**WHEELING PLAN COMMISSION
THURSDAY, FEBRUARY 14, 2019 6:30 P.M.**

REQUEST FOR PLAN COMMISSION ACTION
STAFF PROJECT REVIEW

RE: **Docket No. PC 18-19**
JV Global Services LLC
150 Abbott Drive
Minor Change to Approved Site Plan

RE: **Wolf Road Industrial – Panattoni Development**
1020, 1022, 1026, 1027, and 1030 Carol Avenue; 37 Kerry
Lane; 1020 Plant Road; and 1032 S. Wolf Road
Docket No. 2019-1
Rezoning from the R-1A Single-Family Residential and I-1
Light Industrial to I-2 Limited Industrial District;

TRUCK TRANSPORTATION
CENTER
WHEELING, ILLINOIS

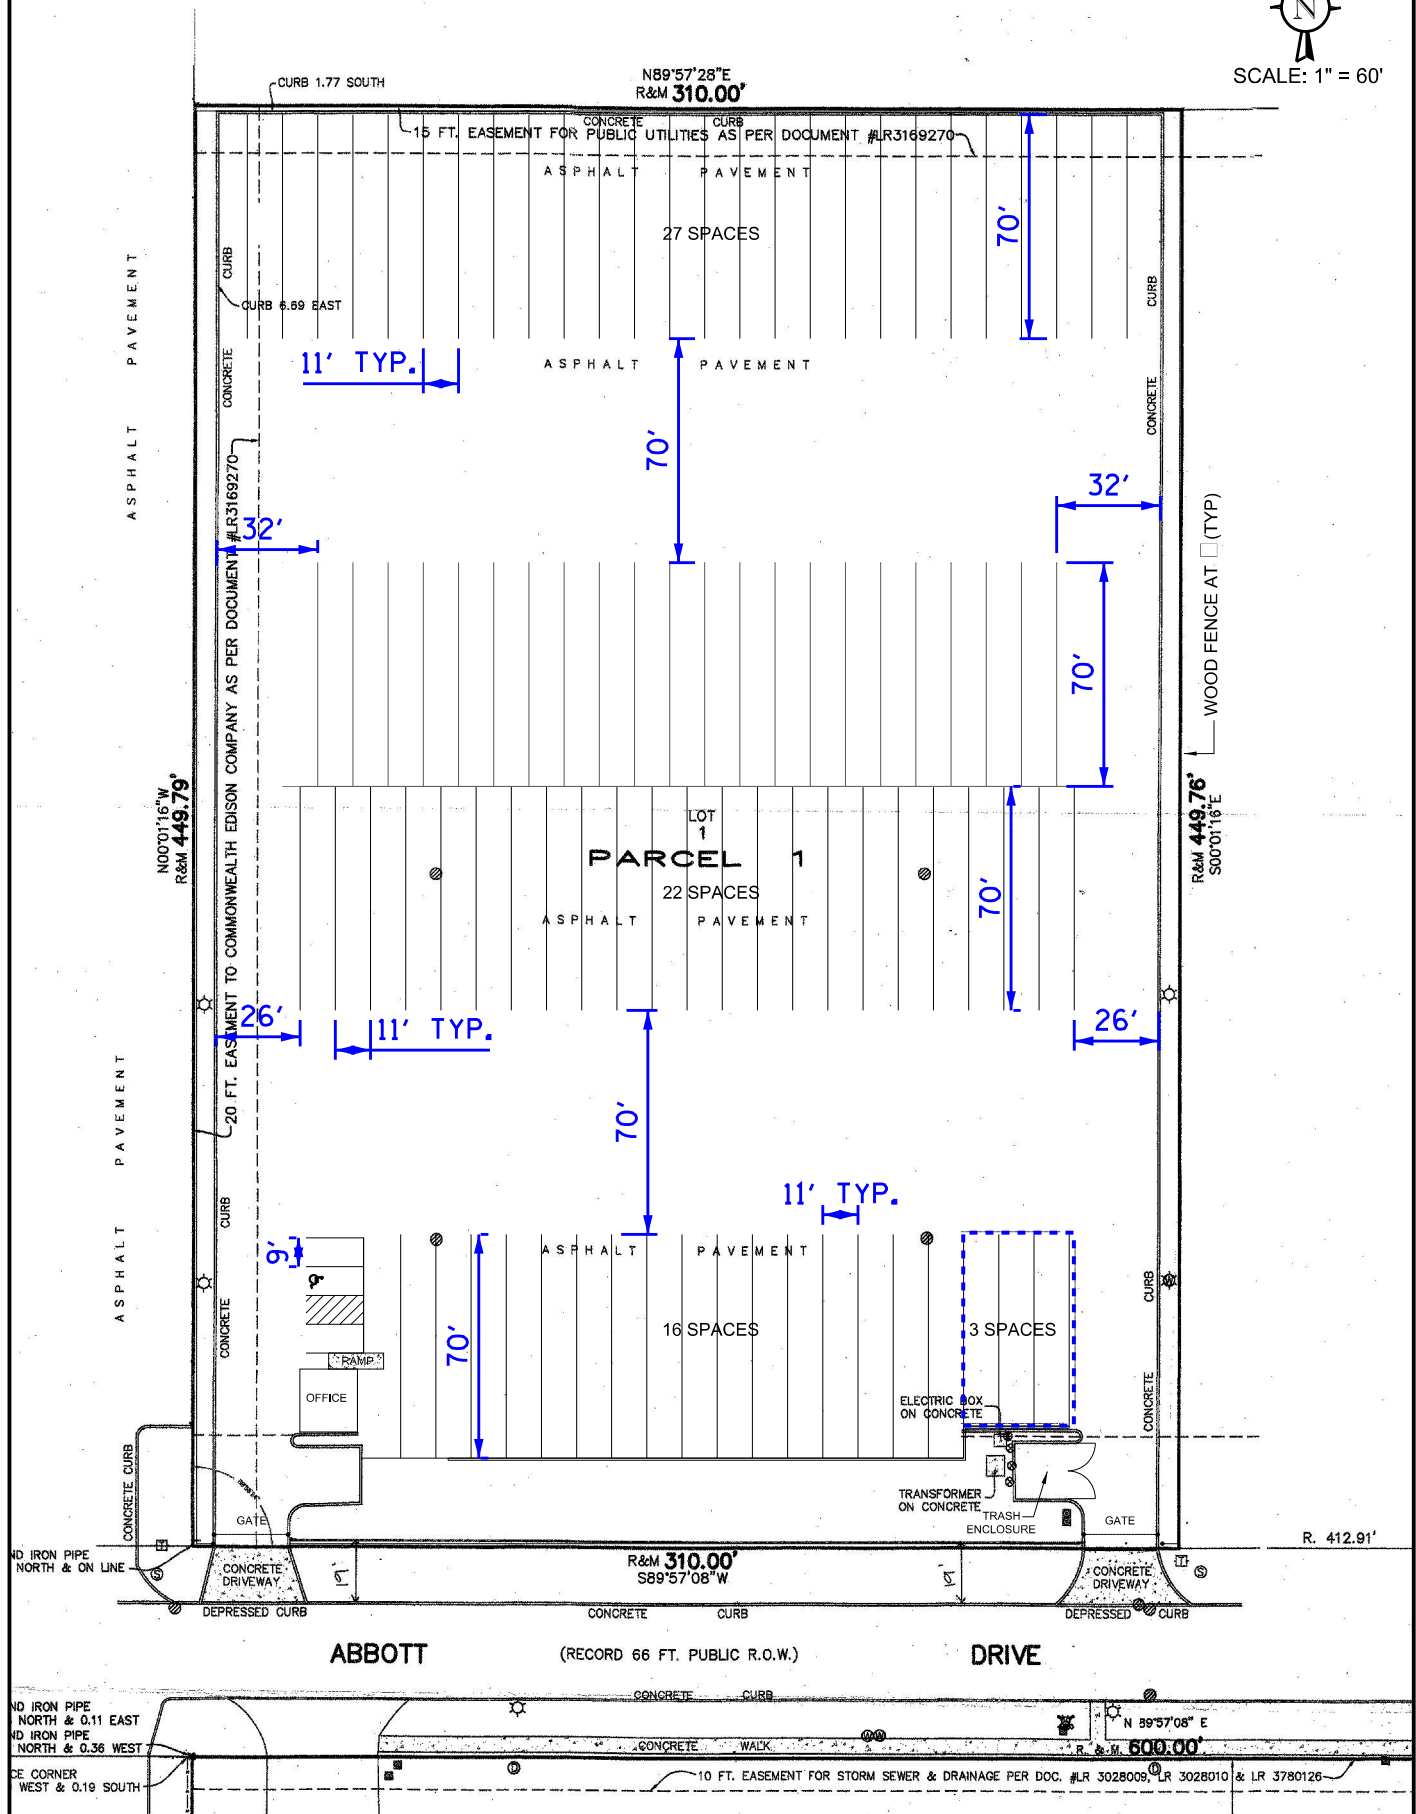
2. Provide a revised site plan to include all dimensions of the parking and include turning radius diagrams ("auto turn") demonstrating the maneuvering of trucks. **The petitioner has prepared a revised site plan with additional dimension details and truck maneuver exhibits, which are attached.**

FIRE TRUCK MANEUVERS

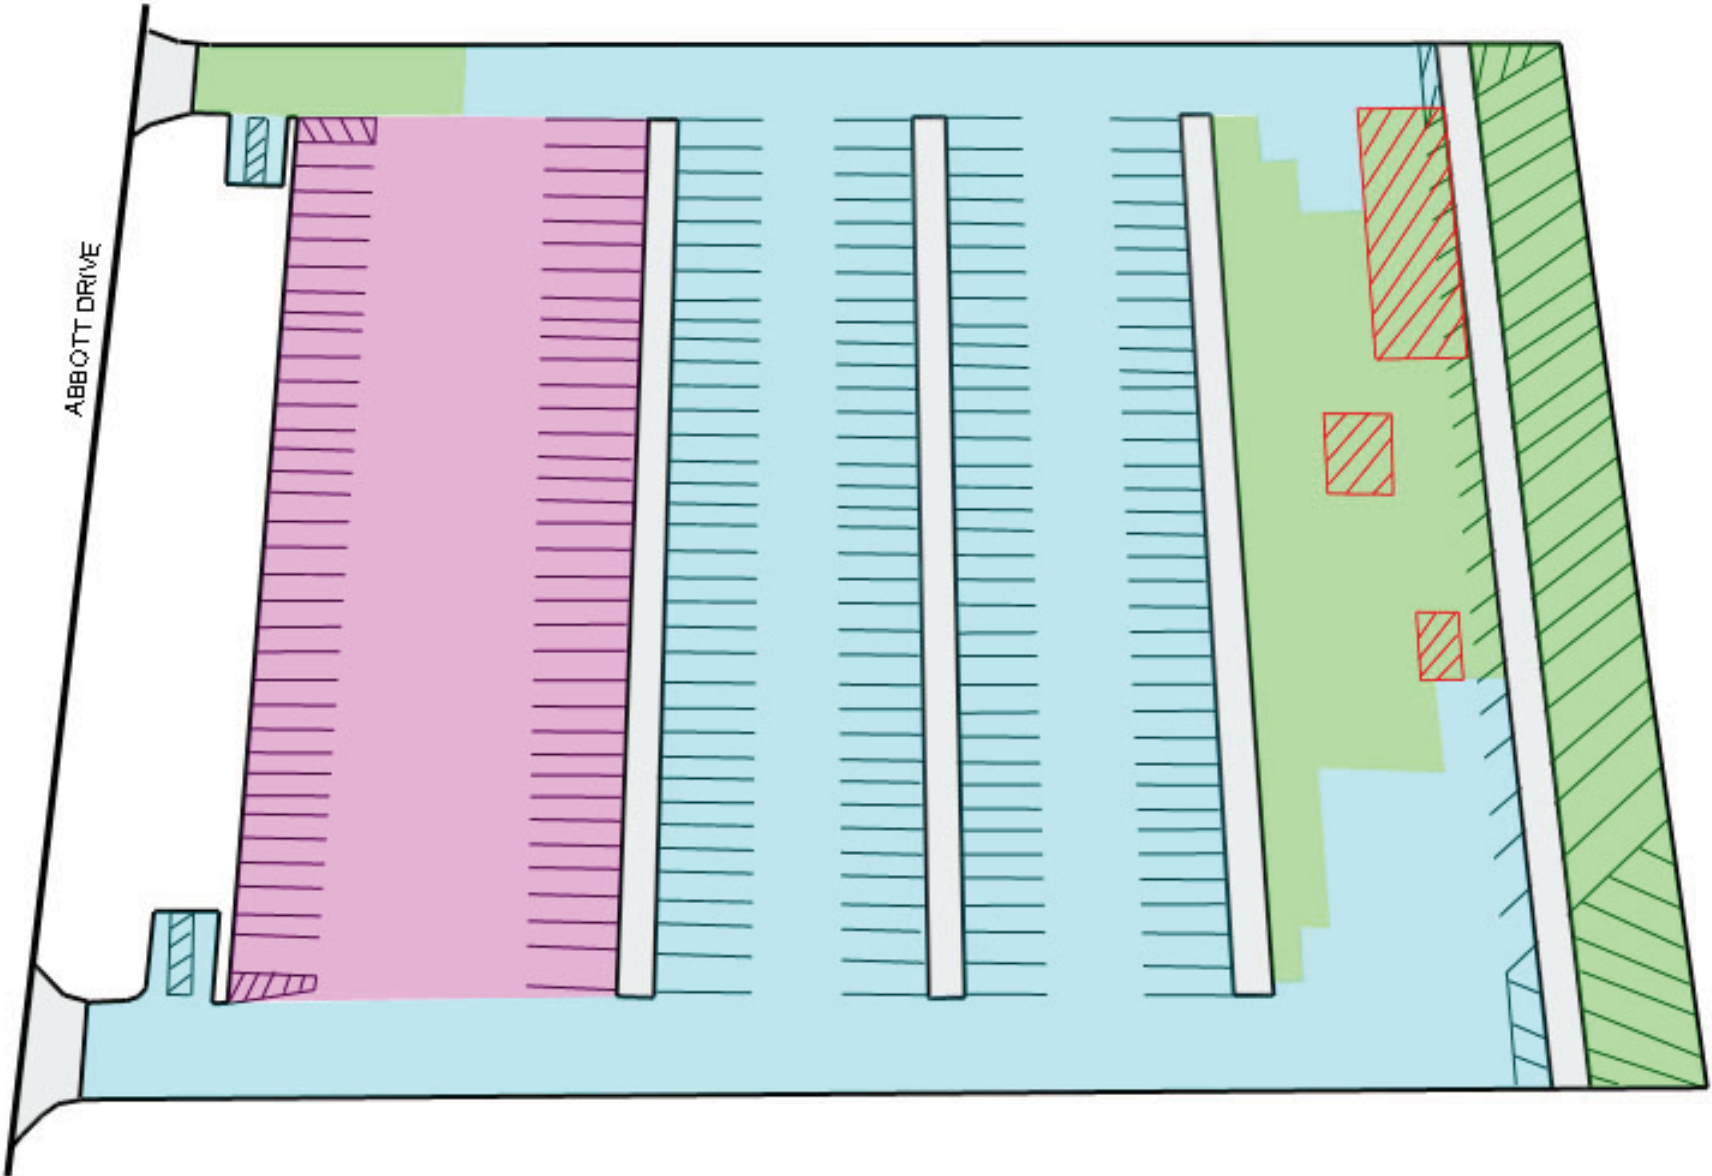
Upon request by staff, the petitioner has provided a fire truck auto turn exhibit for the site based on the reconfiguration of the parking stalls. As demonstrated, a fire response truck can maneuver through the site uninterrupted and there are no conflicts demonstrated.

Fire Department Review: The Fire Department has reviewed the site plan and has indicated the auto turn exhibit sufficiently demonstrates the revised parking layout provides adequate emergency vehicle maneuvering, and further notes that the petitioner's vehicles may require additional movements to navigate the site.

SITE PLAN

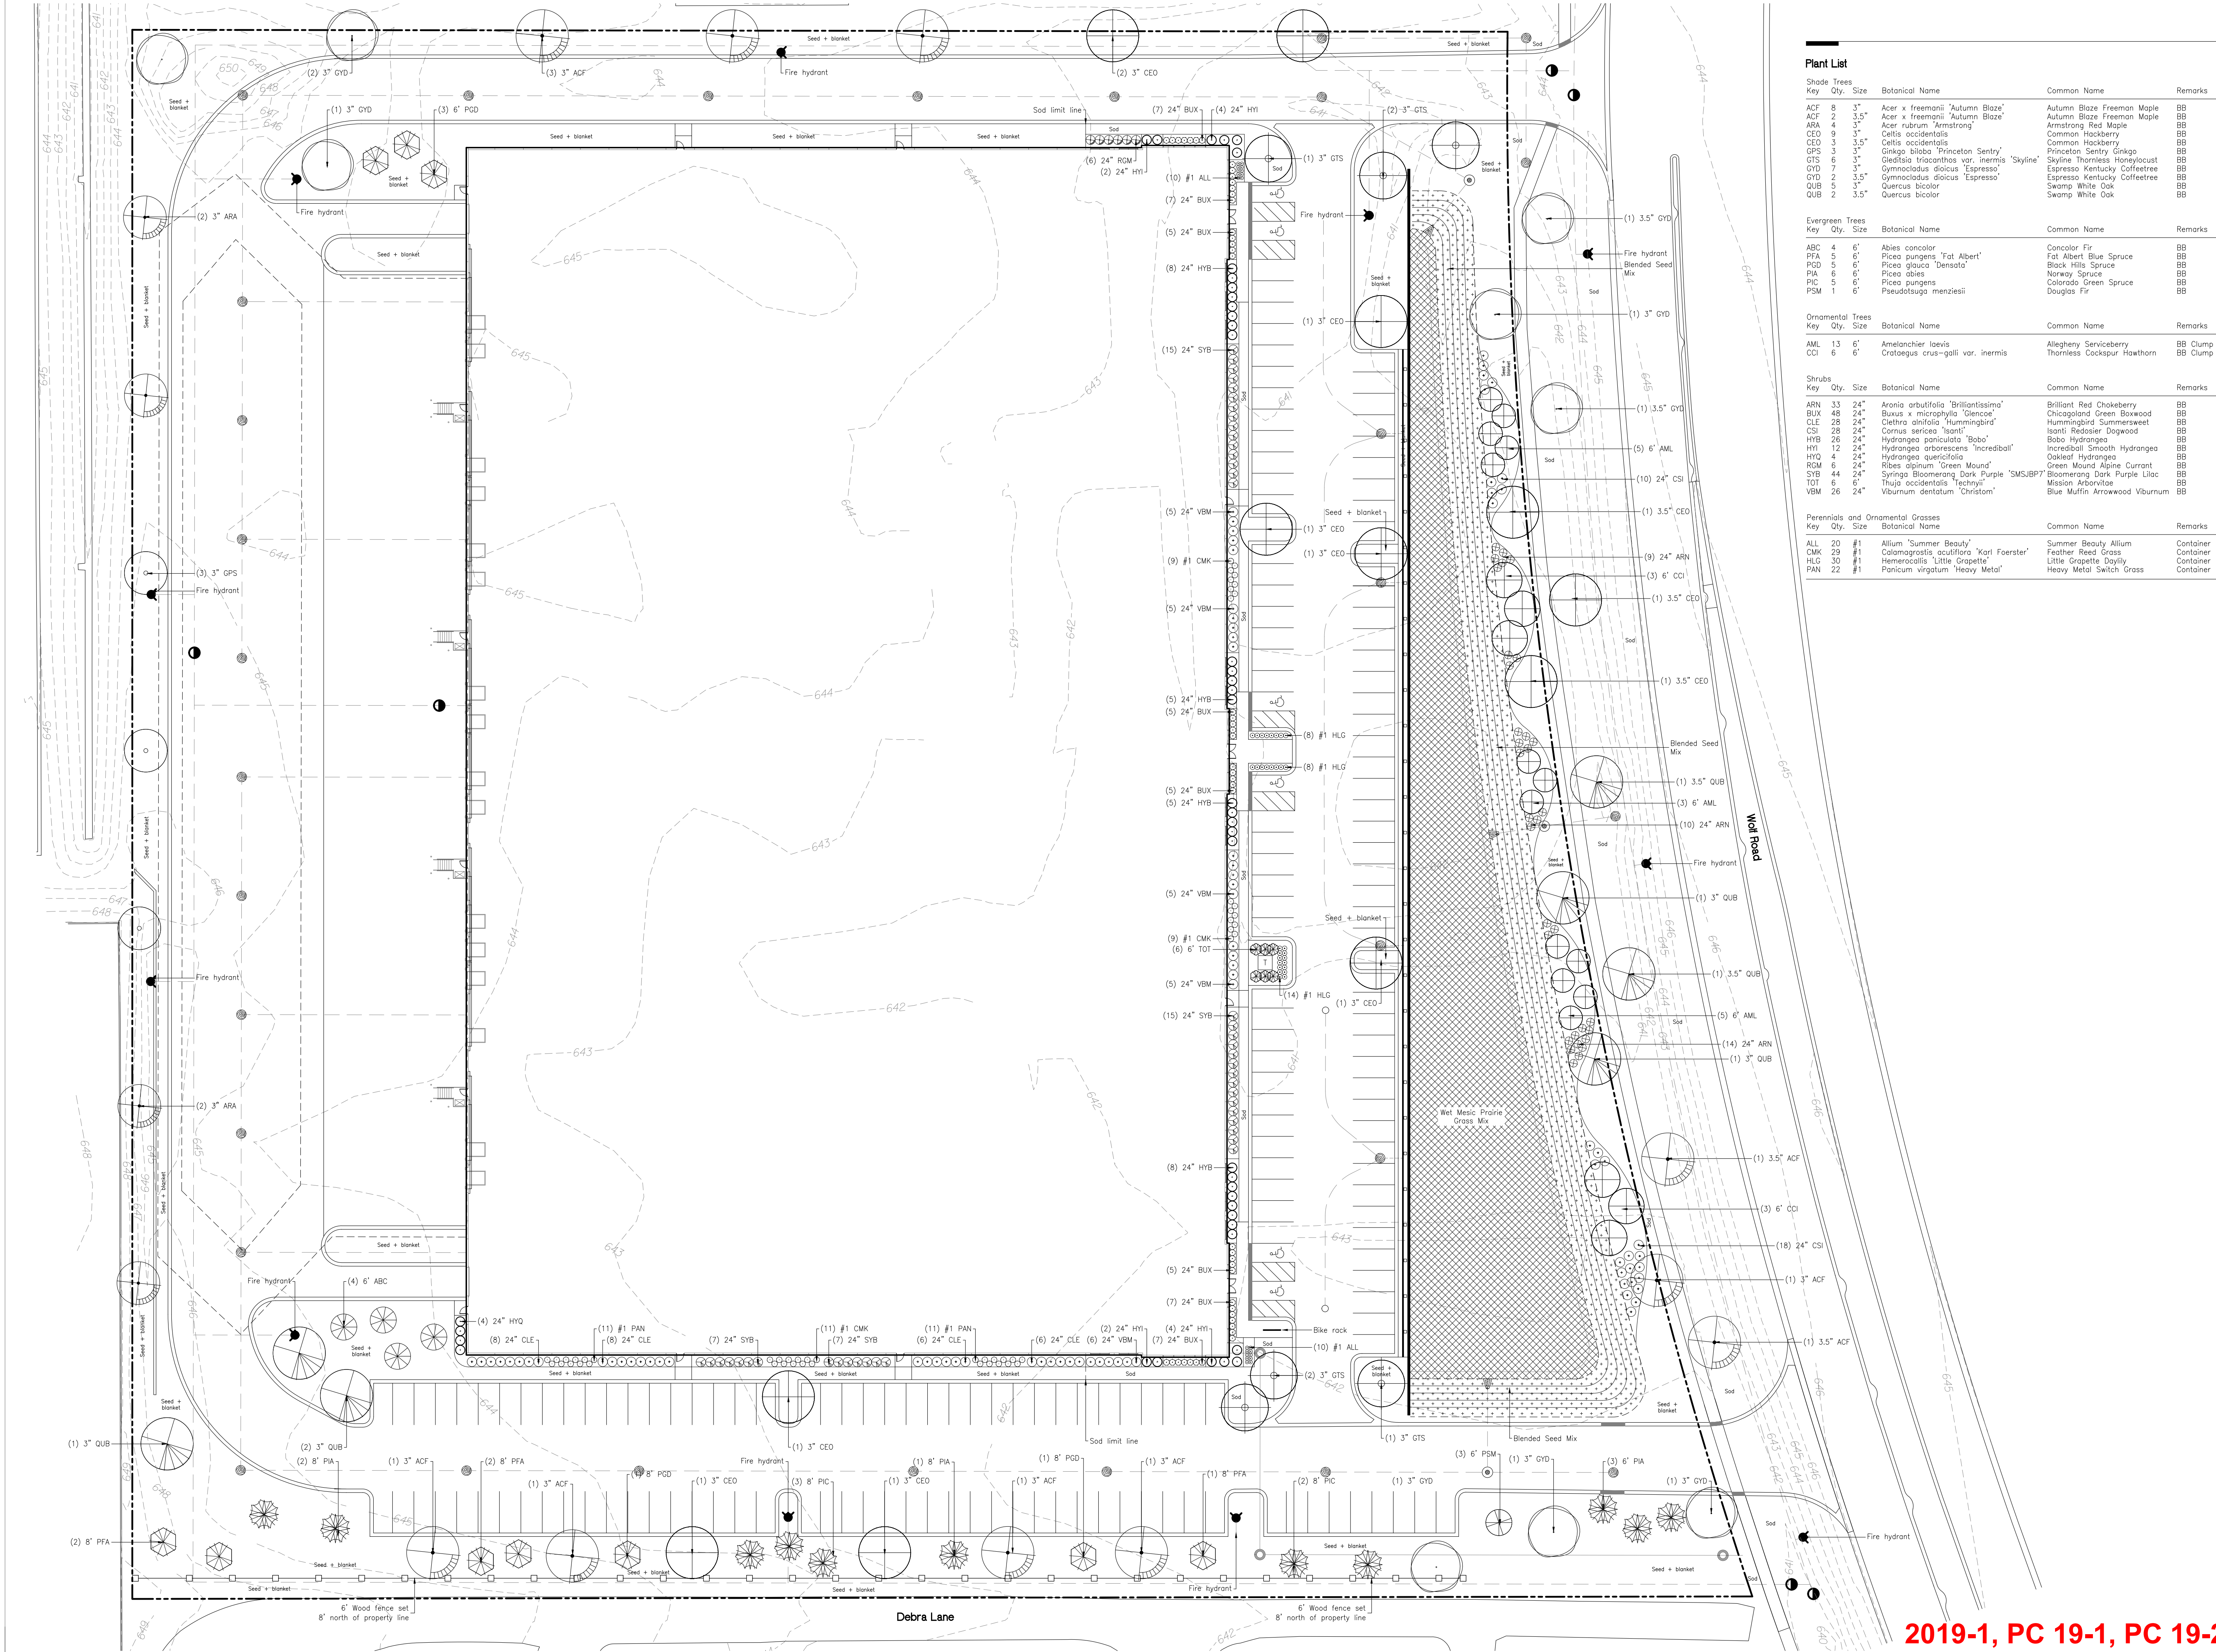
and south of the building, and are connected to provide access around the south and east sides of the building. Loading docks for large truck deliveries are located in the rear of the building (west elevation), facing the rear of the industrial buildings to the west. Stormwater management is provided by a detention basin in the front of the site, adjacent to Wolf Road, which will provide a natural buffer between Wolf Road and the industrial building. Vehicular access will be kept to Wolf Road, with a full-access driveway at the north end of the site and will reuse the current Kerry Lane curb cut at Wolf Road. A second full-access driveway is proposed on the south end of the site to Wolf Road. While there is an existing median in the center of Wolf Road along the south driveway, the median is mountable and does not restrict access to/from the site by any physical barriers.

Floor Plan: As the proposed industrial warehouse is speculative and is not being constructed for a specific tenant/business, a floor plan has not been prepared. The site plan indicates the building could accommodate up to three individual tenants, with offices located on the east side of the building, with the truck loading docks in the rear of the building (west side), which is typical for industrial warehouse buildings.

Bicycle parking: Bicycle parking for 6 bicycles is provided on the plans. The exterior bike rack is located at the southeast corner of the building. Based on 175 parking spaces, Code requires 14 bicycle parking spaces. The number of code required bike parking is high for the industrial warehouse building and the Code allows for a reduction based on indoor bike parking for employees. The petitioner has indicated that indoor bike parking will also be provided, and staff feels the proposed 6 space bike rack is a realistic number.
